PHED COMMITTEE #1 December 10, 2009

MEMORANDUM

TO:	Planning, Housing, and Economic Development Committee
FROM:	Go Glenn Orlin, Deputy Council Staff Director
SUBJECT:	White Flint Sector Plan-transportation issuescontinuation

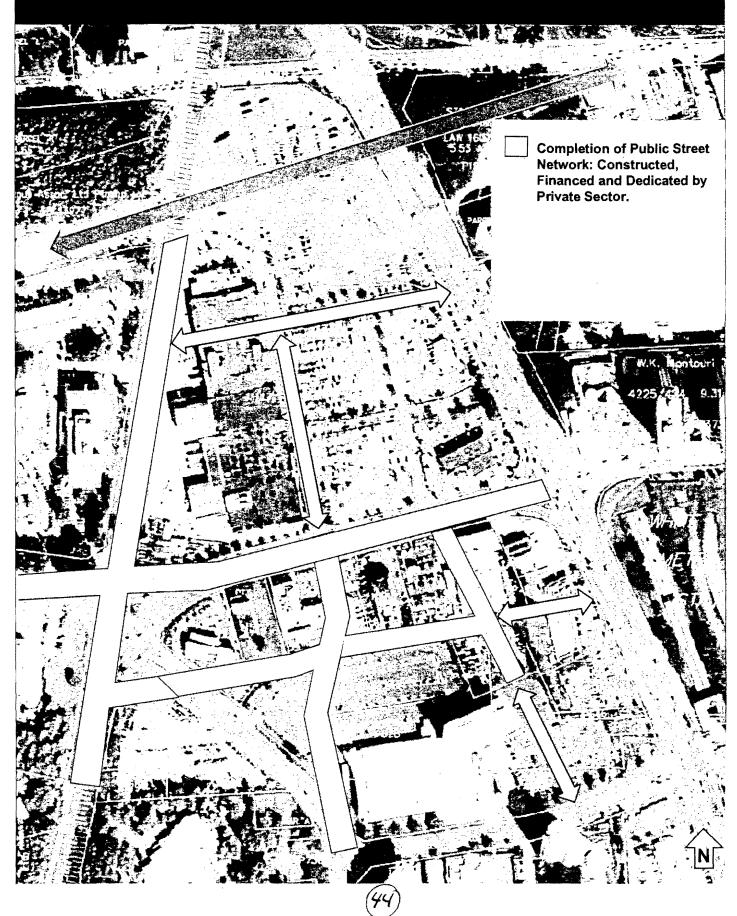
- 11. Bikeway Map Page 57
 - a. How do bikes on DB-14 access SP-50 and SP-41? Map does not show connectivity.
 - b. DB-13 should connect to White Flint Drive and/or Orleans Terrace for neighborhood access.
 - c. DB-13 should have an arrow continuing onto Edson Lane heading west.
 - d. SP-41 should indicate an existing bike corridor instead of an arrow to empty space.
